<b>Name</b>	<b>Signature</b>			<b>Date</b>
Application made by:	SCSVJ				12/04/2024
Location (Sector/Site Name):	Alexandra Road – WP26.9 Group A2				
LAA/LAP/Site Reference					
Work Package number:	WP26.9 Group A2				
Date of Tree Panel:	18/04/2024				
Site Description:	Alexandra Road – Gas Main Replacement				
Reason for clearance:	Gas main requires replacing as part of the asset protection programme. Tree has grown directly over gas main and it is not possible to replace without removing the tree				
Drawing Reference No.:					
	Yes	No	N/A	Comments	
Has the Stage 1 Survey been completed and logged on the Register	x				
	Yes	No	N/A	Comments	
Has the Stage 2 Survey been completed with retention and protection measures logged on the Register	x

### Tree Panel Outcomes

Figure 2: Google Street View of T141

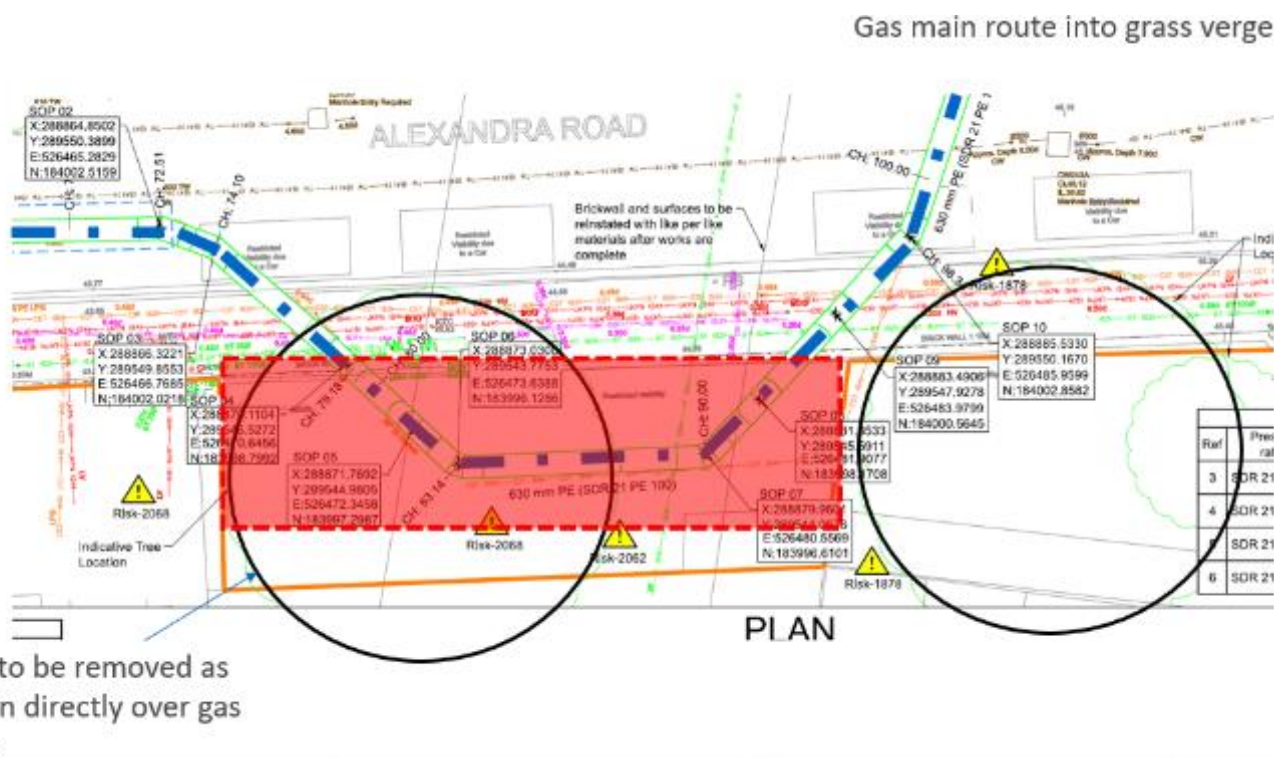
<p><b>Have all practicable means to negate need for works to tree been investigated? Please provide details</b></p>	<p>A number of options have been reviewed prior to choosing to remove the tree.</p> <p>Reroute gas main to other side of road is not possible due to size of gas main. This work package is for a medium pressure main, the gas main in the road is a low pressure gas main</p> <p>Reroute gas main within the road. This is not possible due to the depth of the road at this location. There is a TfL rail bridge under the road which limits the depth of the road.</p> <p>Leave gas main in place. the size of excavation, we would still disrupt the roots and tree significantly, meaning it would still have to be removed.</p> <p>Transplant tree. We have consulted with arboriculture specialists and this would need significant space to be able to carry out the work. The roots are expected to have grown around the main and would be damaged in the process. It is expected that the tree would not survive and die posing a health and safety risk.</p> <p>Only feasible option is to remove and replace tree. Replacing tree to be carried out as part of reinstatement</p>

T141 – Purple Norway Maple – to be removed and replaced

Proposal Endorsed/Not Endorsed:	Endorsed with conditions
Conditions	Endorsed, a replacement tree to be planted in the area before works complete.
